RotorSport UK Ltd

Service Bulletin

SB No.: 019 issue 2	CCAR No.: None	Classification: OPTIONAL or RECOMMENDED or MANDATORY
Aircraft type & model (applicability) RotorSport UK MT-03 and MTOsport series	Aircraft serial Nos. effected RSUK/MT-03/all RSUK/MTOsport all

Instructors have requested that aircraft already in service can be converted for training use by fitment of rear-seat controls. This SB details the various options and how they are to be fitted to aftermarket aircraft.

Installation of the rear-seat ASI, its marking, and tubing

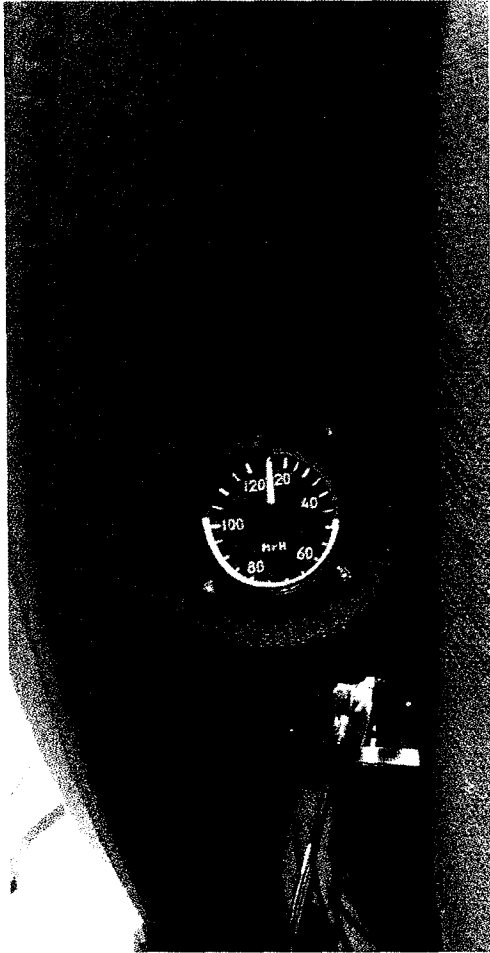
5. Cut the holes as shown in the rear panel and fit the switches. Rivet the earth wire to the airframe (there is a spare hole adjacent).
6. Fit the rear seat ASI. The ASI is located at an angle to the ground of approx 40deg, and around 23cm from the top edge of the front seat (see photos). Offer the bracket into position, and mark out the area.

7. Drill thru the seat for the two rivets, approx 15mm apart to suit the bracket. Then mark out the bracket against those holes, and drill to suit (4mm holes). Clean the area, and pop rivet the bracket in place (washer under the rivet head).

8. Then fill the gap between the LHS of the bracket and the seat with Sikaflex EBT. When cured, fit the ASI with the screws in the box, and connect to the harness supply tube with a length of silicon sleeve. Note - fit the ASI marking before fitting the ASI! Red line is 120mph for the MTOsport, and 100mph for the MT-03. When filling with EBT, mask the area, and smooth down with a wet finger.

- Note that there are two different markings:
- MT-03 (identified by Vne marker at 100mph)
 - MTOsport (identified by Vne marker at 120mph)

Installation of the switches (all holes to suit switches)

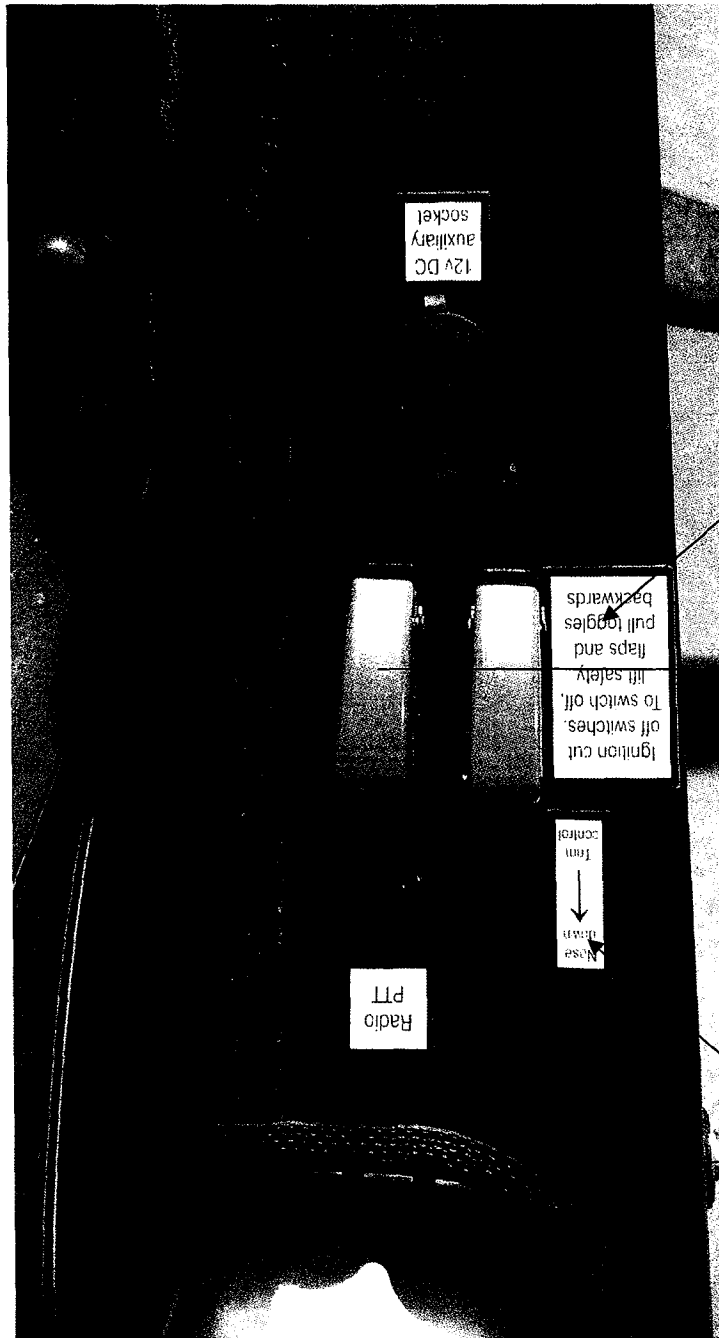
“Ignition”
placard to left
(i.e. outboard) of
switches

Approx 88mm
Switch centres
29mm

“Trim” placard
to left
(i.e. outboard) of
rocker switch

B) Throttle

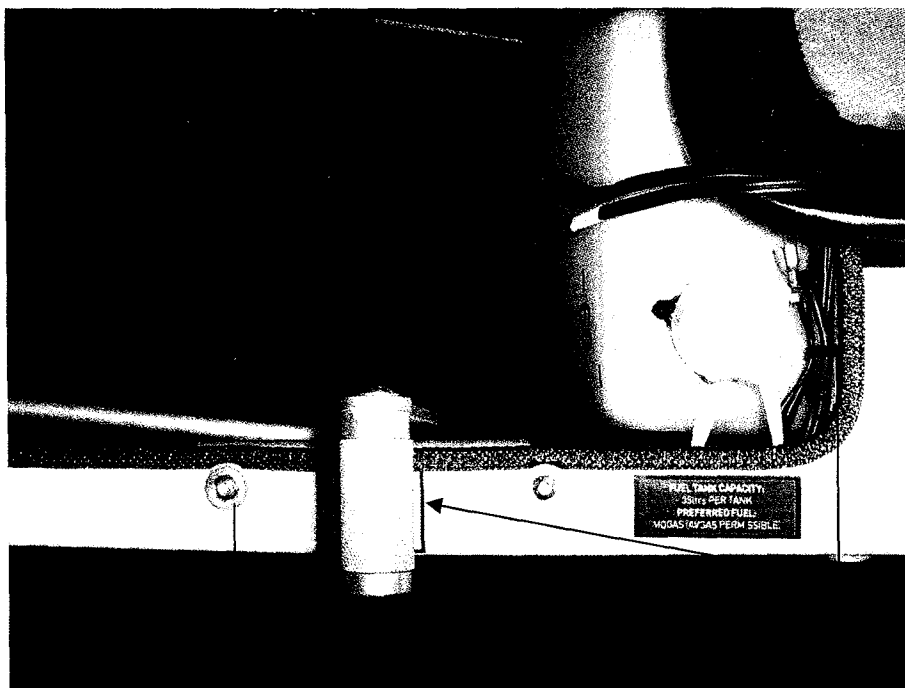
1. Mark-out and drill two 6mm holes positioned as shown below. Fit the throttle assembly to the enclosure using the M6 screws, steel washers, nylon washers and nyloc nuts supplied in the kit.

“Throttle” placard centrally between screws under throttle lever.

Distance to fwd hole 235 – 240mm
Bracket edge 2mm clear of trim strip

C) Brake (it is a pre-requisite that a rear-seat throttle has been installed)

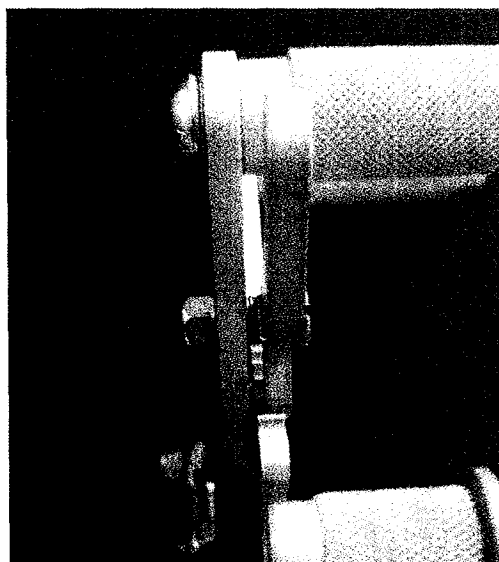
1. Check rear seat throttle blade holes are present and ready to accept brake. If not present, replace blade (part number is M.ST28.01.01). Check also that front brake lever has a spring fitted. If not, replace brake lever with new assy RSD7192 (see photo below to see spring location).

Spring

View of rear seat brake, supplied pre-assembled with cable attached

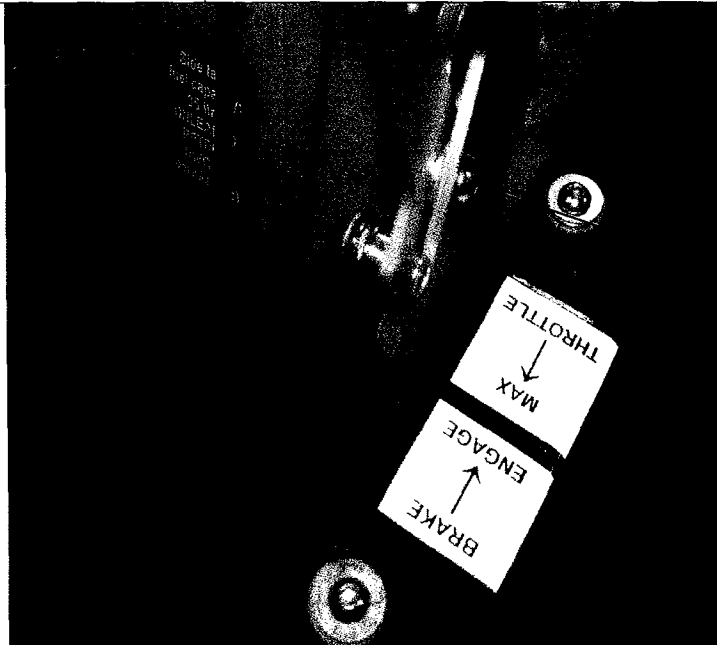
2. Assuming blade is correct, fit cable bracket to lever as shown. Then fit rear seat brake arm to lever as shown. Tighten pivot nut until there's little backlash, and still free pivot.

Attachment to lever - dome bolt, steel washer between levers, nylon washer, plain washer and nyloc.

The two placards are fitted centrally between the mounting screws and to the left, (i.e. outboard) of the controls. Clean the composite surface with a suitable low-odour solvent (e.g. Amberklene LO30) prior to placing the placards.

Cable mount bracket. Fitted with countersunk screw,
two plain washers, the bracket and nyloc nut

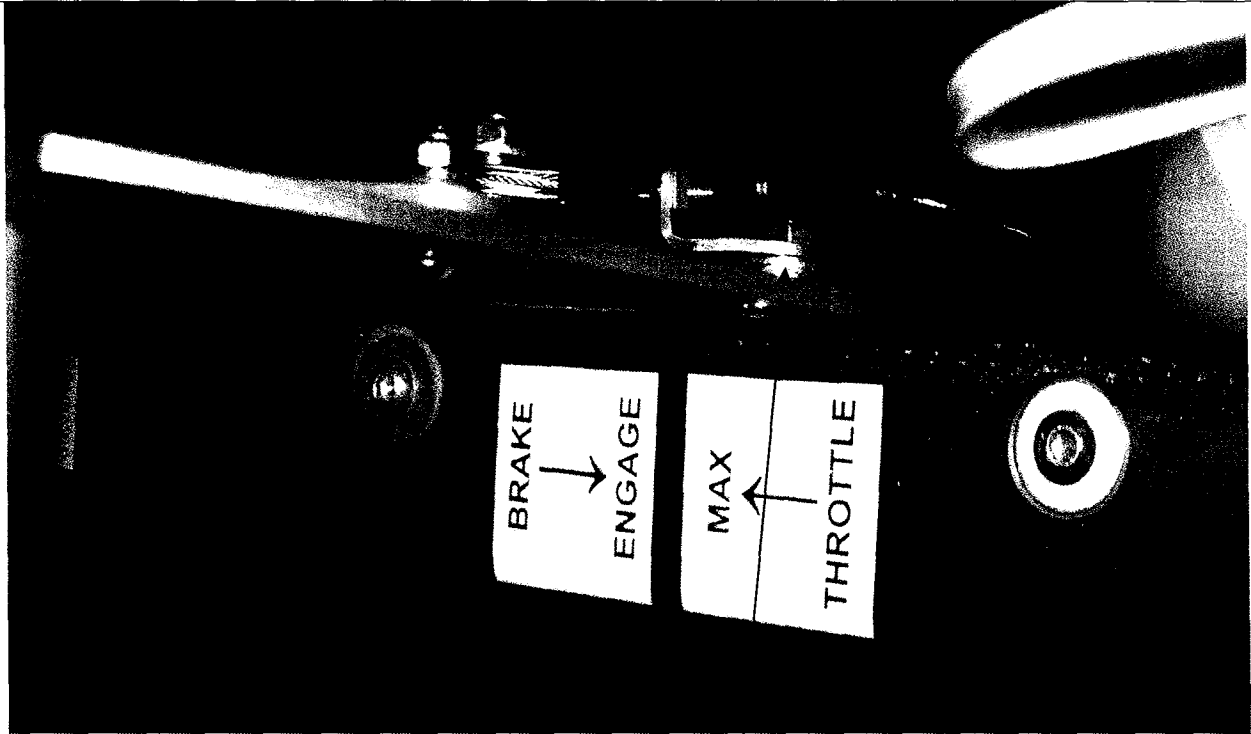
3. Remove lower brake cylinder bolt on throttle body, and replace with longer countersunk screw in kit (M6x35). Attach cable mount bracket as shown. NB: to improve access to the countersunk screw head temporarily remove the fwd throttle stop screw and gently push the throttle past the stop point. Replace the throttle stop screw at the earliest opportunity, with loctite 243 on the thread.

View showing connection to cylinder (front-seat controls)

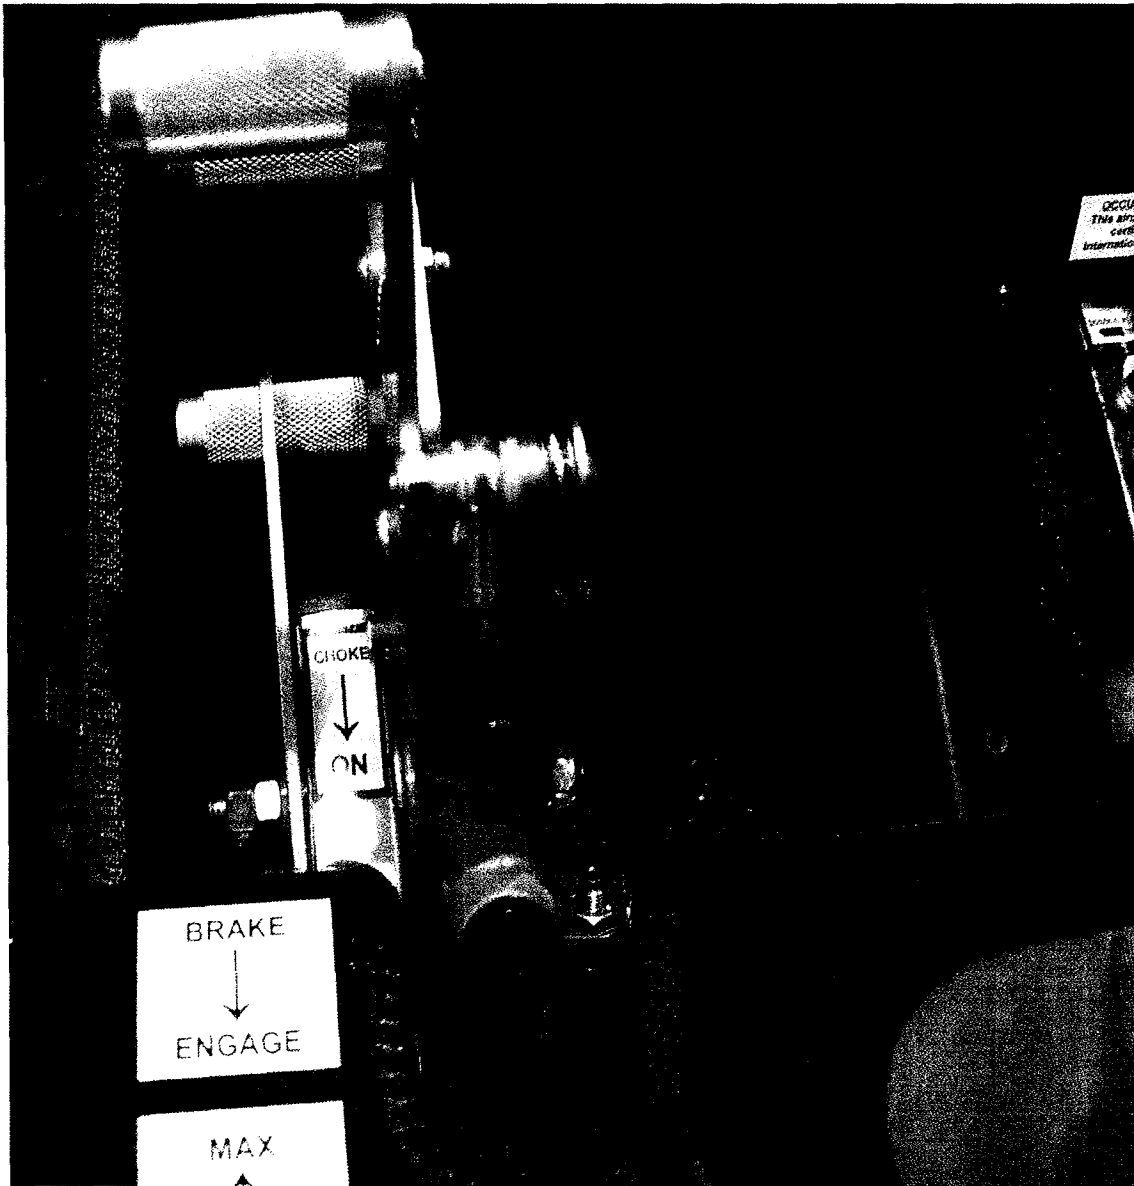
This pivot must not be overtight, or brake lever will not fully release!

View of cylinder with longer bolt fitted

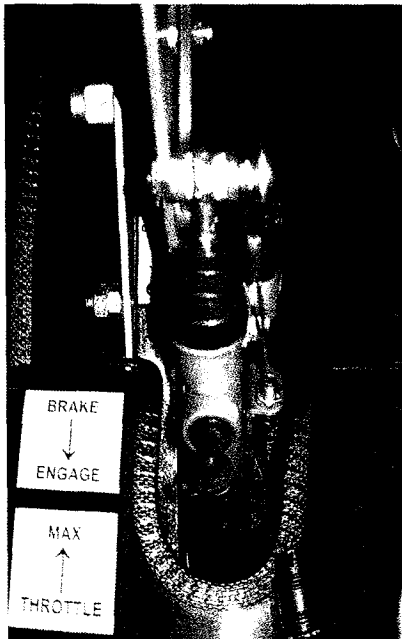
4. Remove bolt attaching cylinder eye bolt and replace with bolt from kit as shown (M6x35 dome head). Fit cable end as shown
5. Adjust cable so that front brake lever can reach its "off" stop without interference from the rear lever cable fitting.

Note! Ensure levers do not foul seat when retracted! If necessary, pull off the edge trim, cut back the seat edge, and refit the trim!

View of brake cable attachment.
plain nut on top of cylinder, two plain washers,
the bracket, and the one nyloc nut
